Square Vis Architects Inc.
www.sqvis.ca

Addendum ADD#2

Date: June 1, 2026
Project Name: Verona Housing
Project Address: 6094 Carleton Dr, Verona, ON K0H 0B8
Project Number: 26001

1 C-103 SITE SERVICING-01
SCALE: 1:200

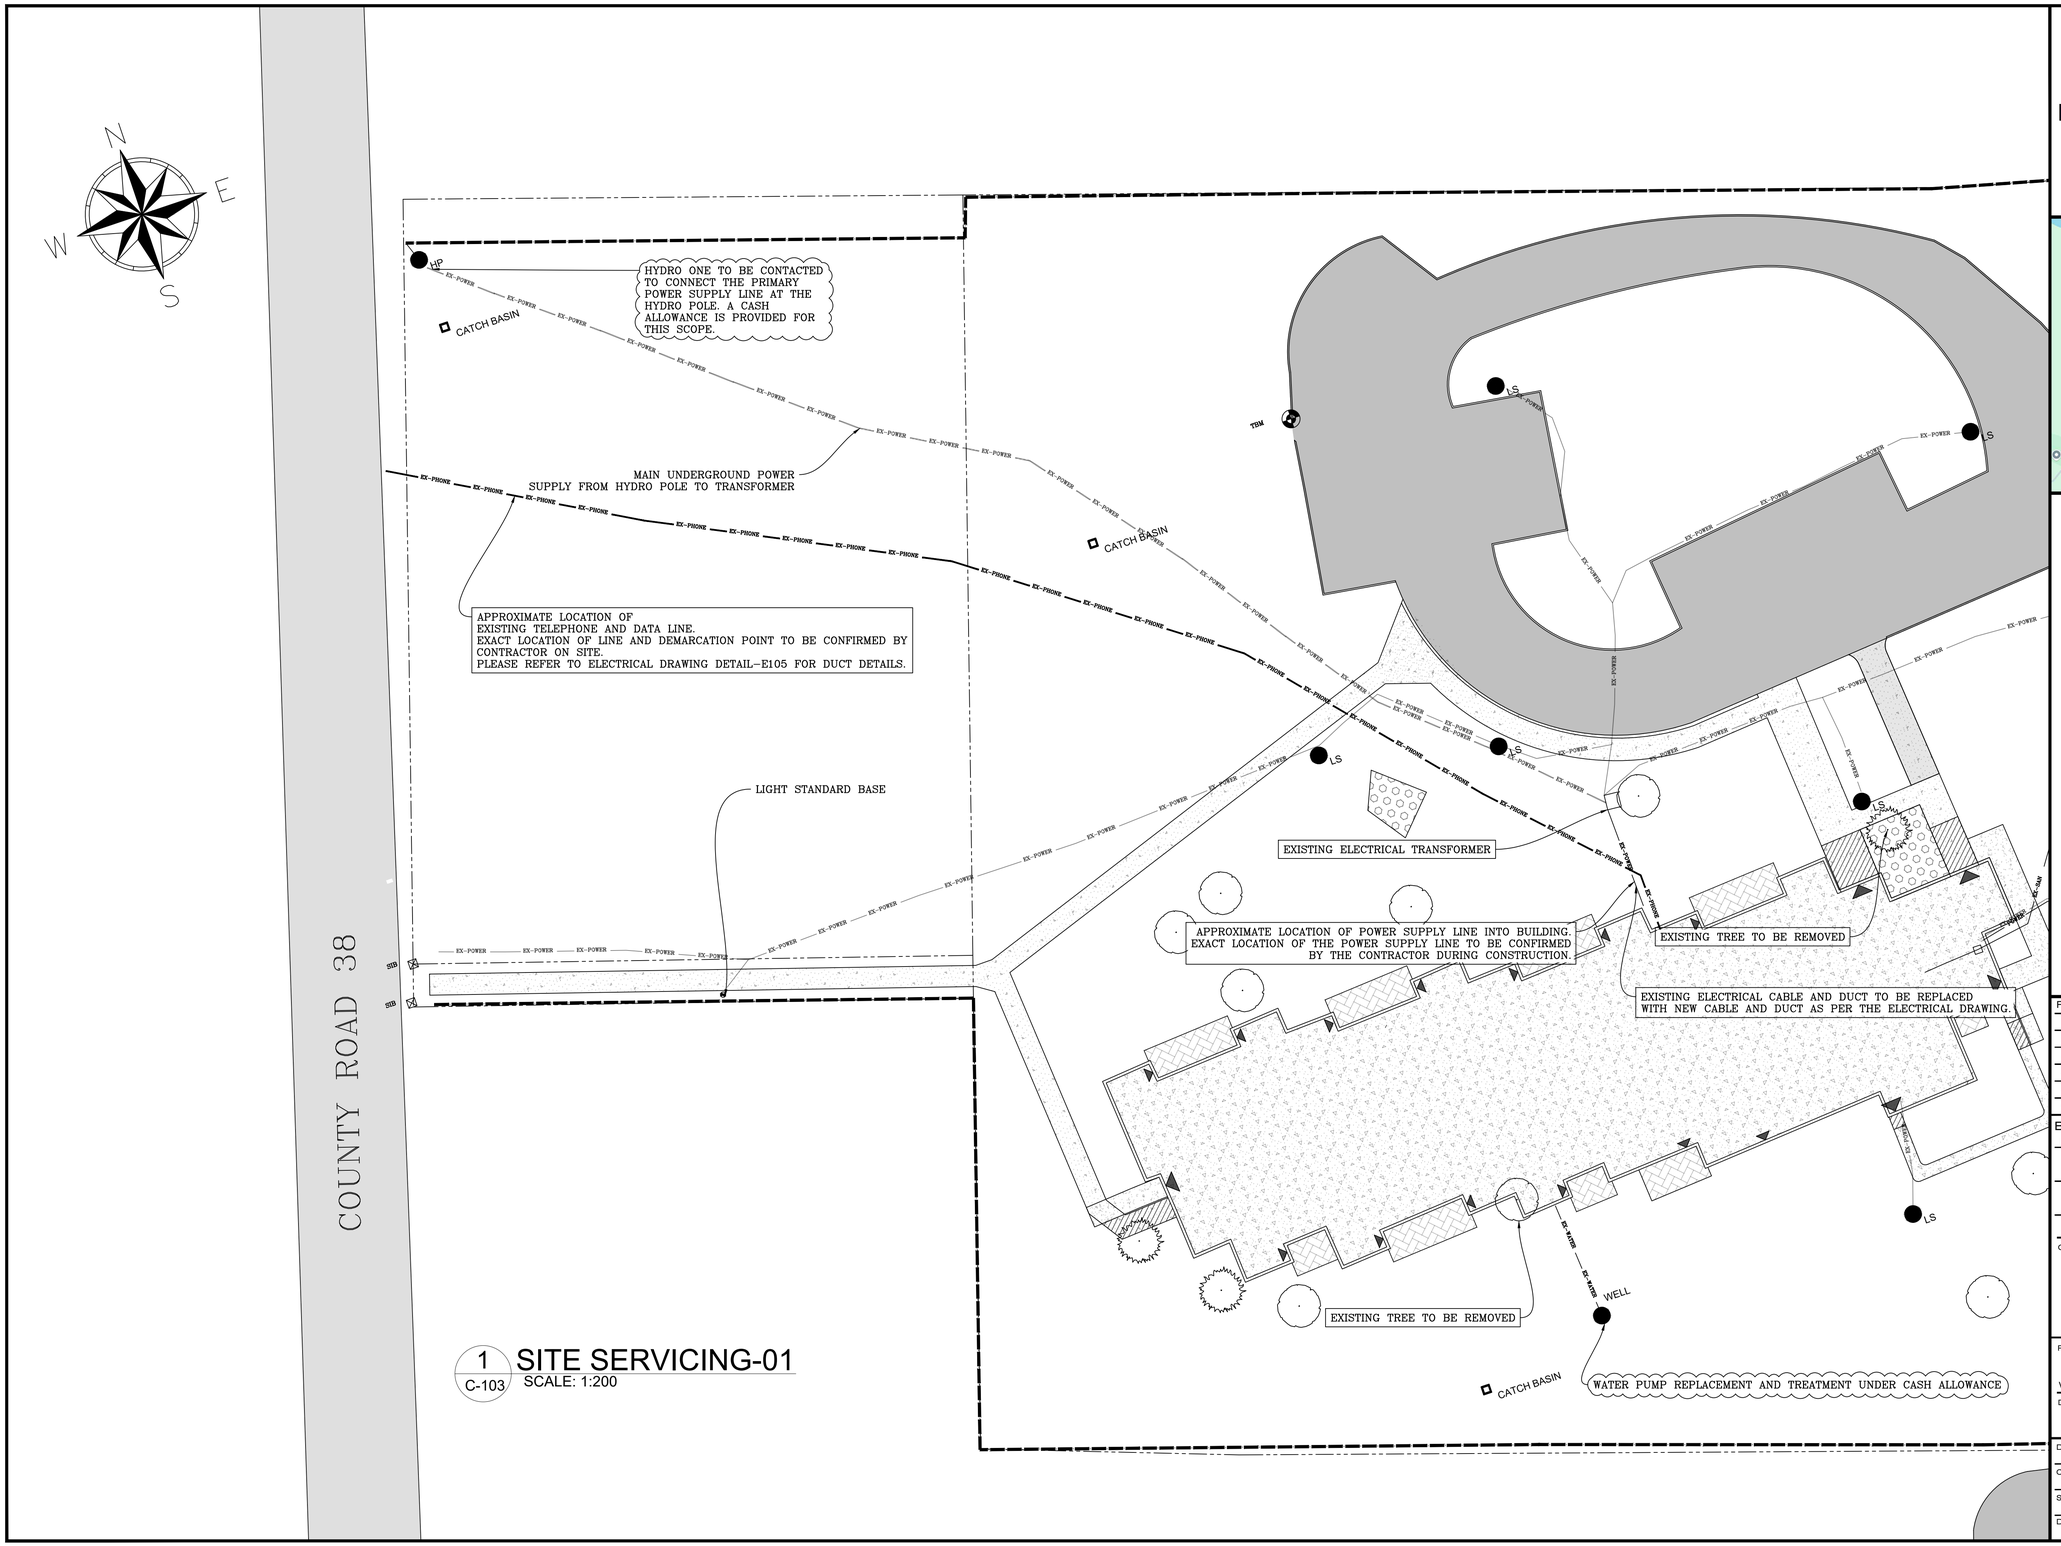
2. **Description**
   a. C-103: Revise note for payment of Hydro One work on electrical service
   b. C-103: Revise note for payment of water pump replacement and treatment system supply and installation
   c. C-104: Revise note for payment of sanitary forcemain testing

1 FOUNDATION FLOOR PLAN - RADON

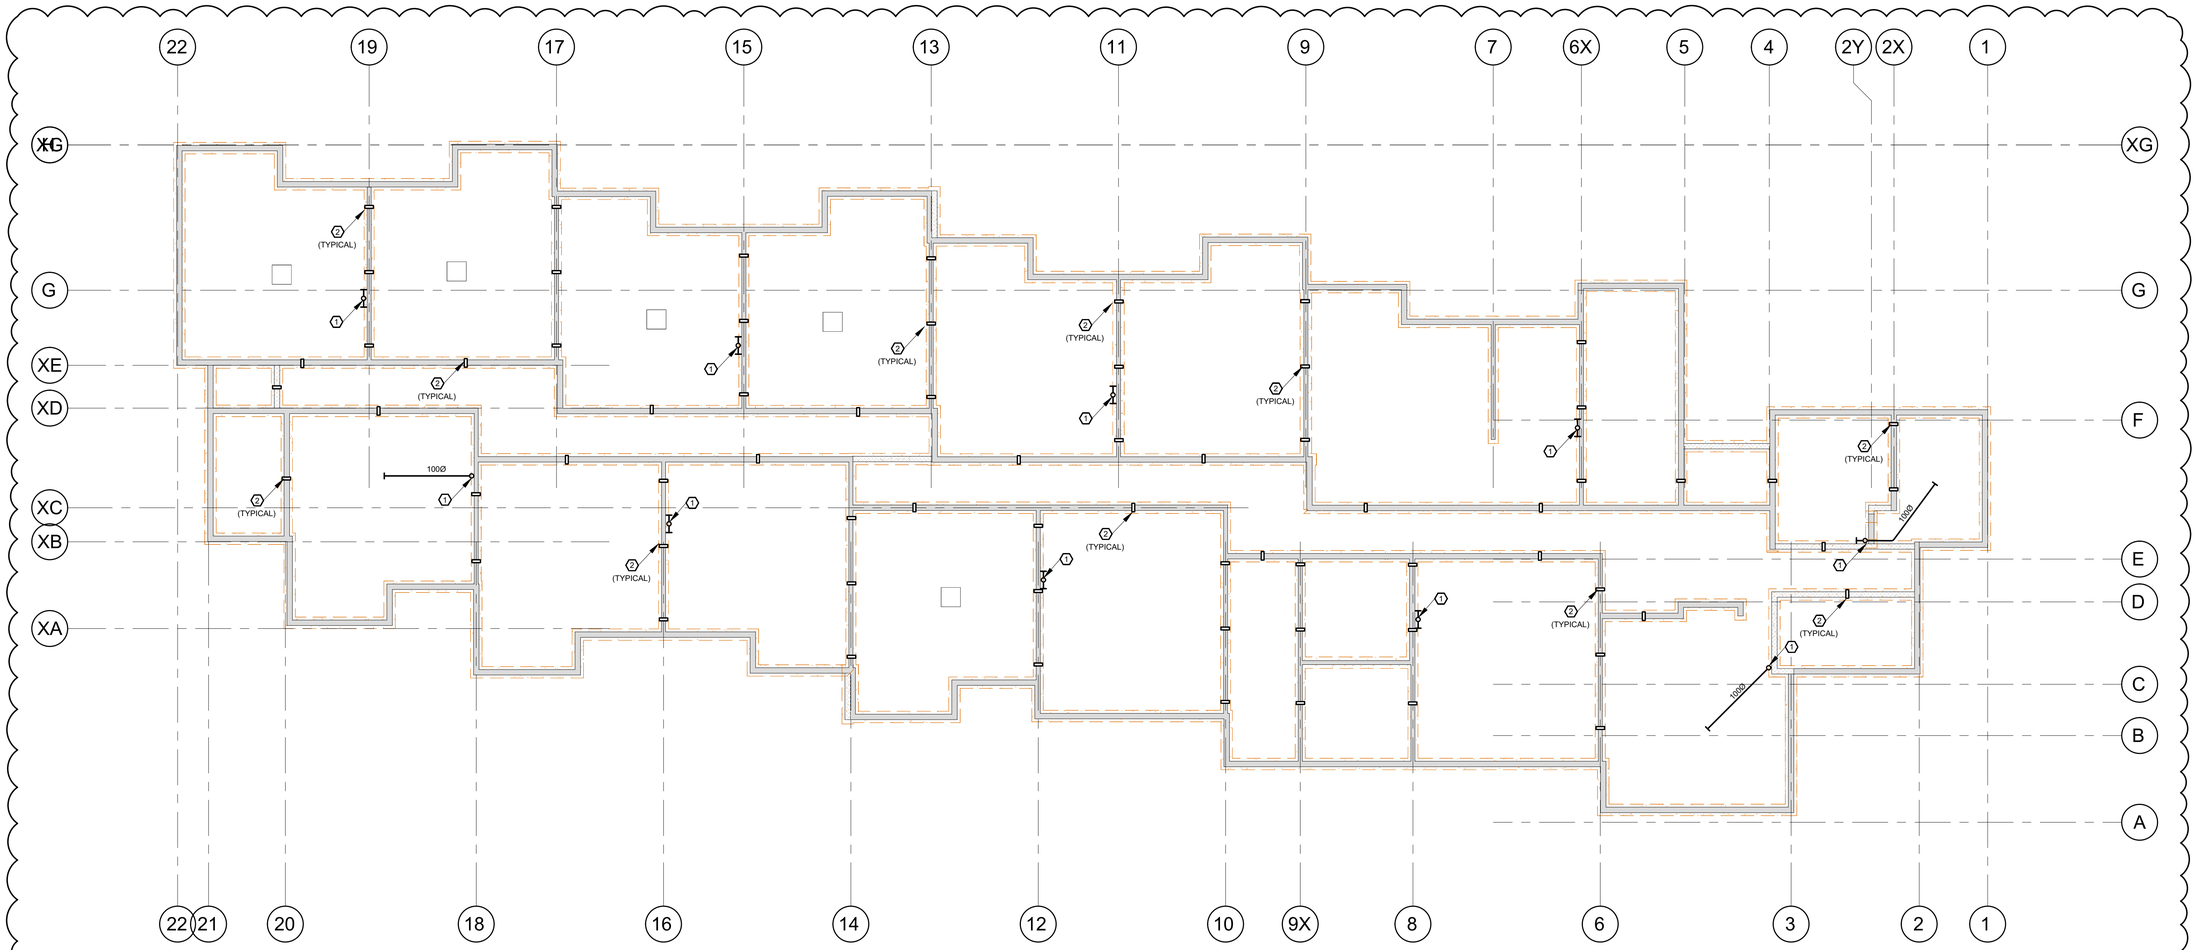
M100F, M100
- New foundation drawing added for Radon prevention rough-ins.

SHEET NUMBER: M400

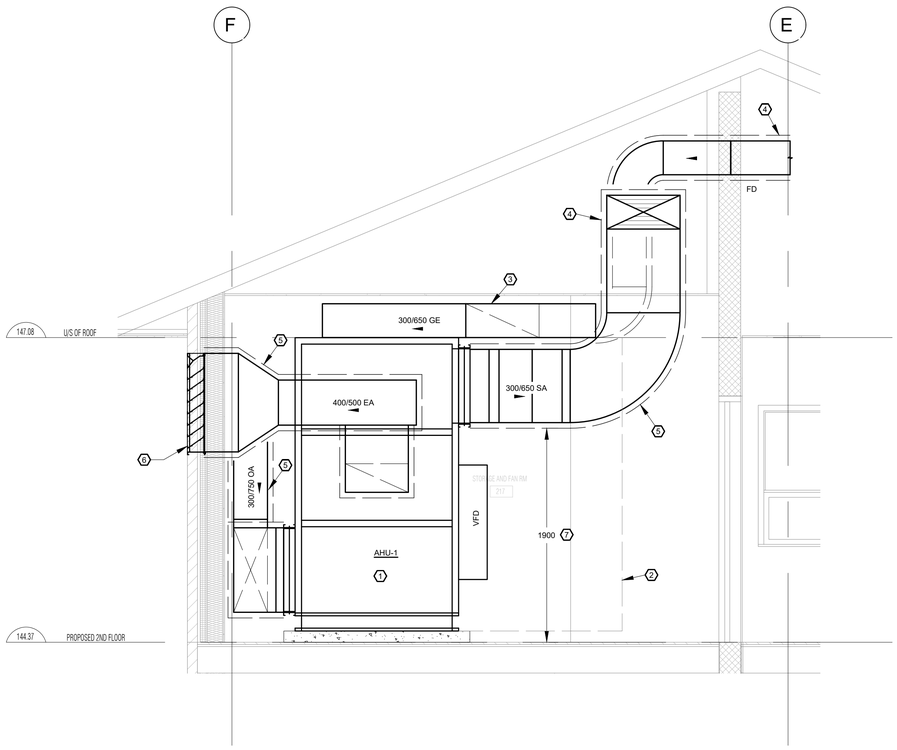
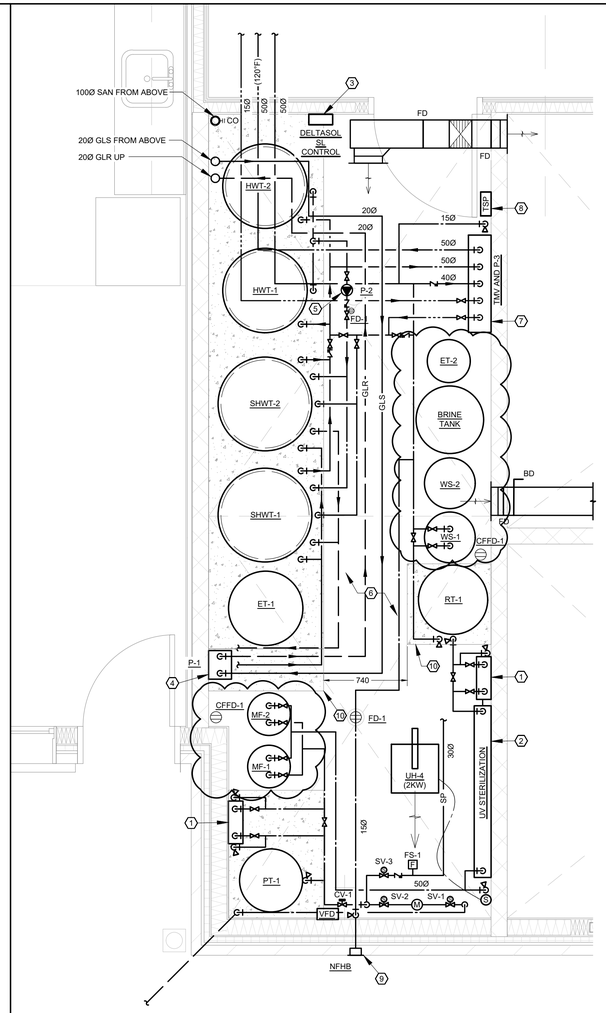
M400
- Updated housekeeping pad locations.
- Added two combination funnel floor drains.
- Added well pump VFD.

1 FIRST FLOOR PLAN - PLUMBING AND DRAINAGE
1:100

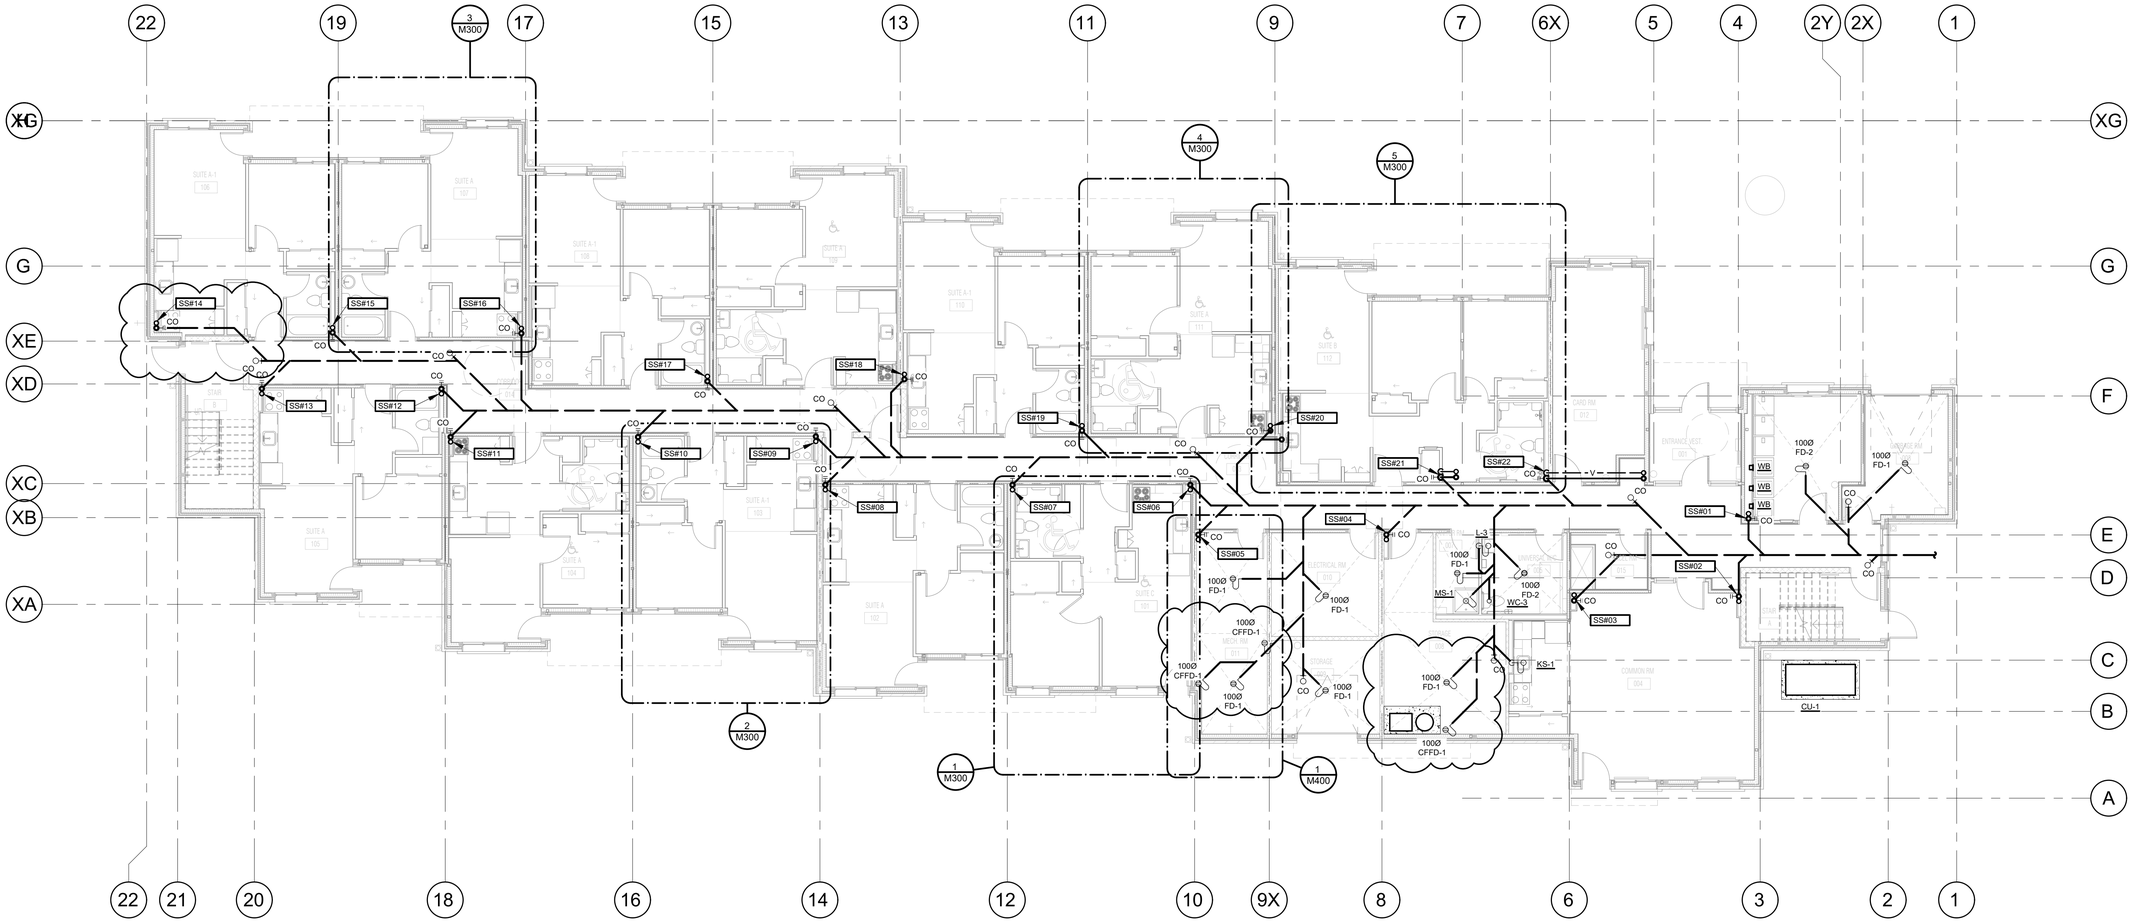
P001
- Added three combination funnel floor drains.
- Relocated end-of-line cleanout to outside of Stair B.
